**Chesterfield Oaks (Capitol Land)**: An Amended Sign Package for a 7.4 acre parcel zoned "PC" Planned Commercial District, located east of Clarkson Road, south of its intersection with Chesterfield Parkway East.

RE: Chesterfield Oaks Shopping Center Sign Package Amendment

Re: Chesterfield Oaks Shopping Center

**SIGN LAYOUT ON MULTIPLE ARCHITECTURAL ELEMENTS**

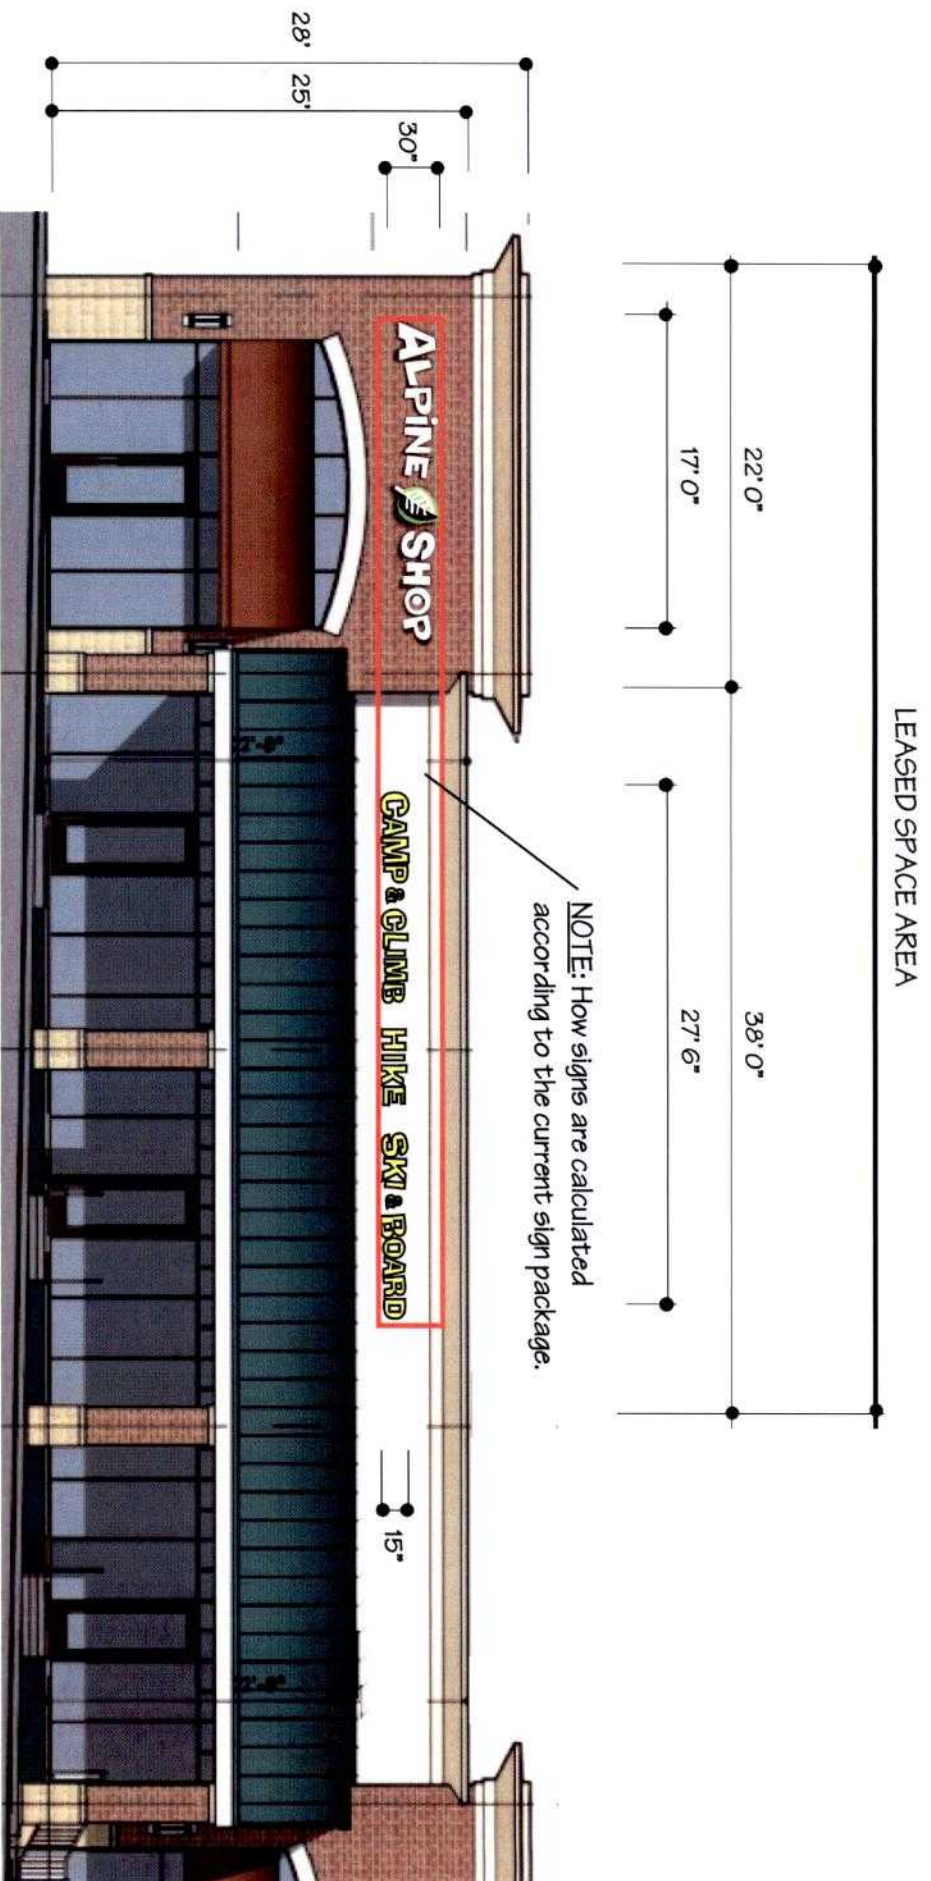
The attached layout is for the "Alpine Shop" sign at the Chesterfield Oaks Center. This layout example is unique because there are two store front wall elements, and, because the store front elevation has different planes. We feel that this layout is the appropriate way to present the sign. When the layouts are calculated at each element, the signage does not exceed the maximum allowable area. When the sign layout is calculated using the distance between the elements the sign area exceeds the current sign package.

NOTE: Signs do not exceed maximum allowable sign area if calculated individually.

HARDSHIP: Two (2) different architectural elements -- brick & drivt areas

2. (vi) When Lessee’s leased premises has different front building elevation elements (i.e. brick fascia, E.I.F.S or a M.D.O sign band) multiple signs are permitted, provided such signs shall not exceed the maximum allowed size.”
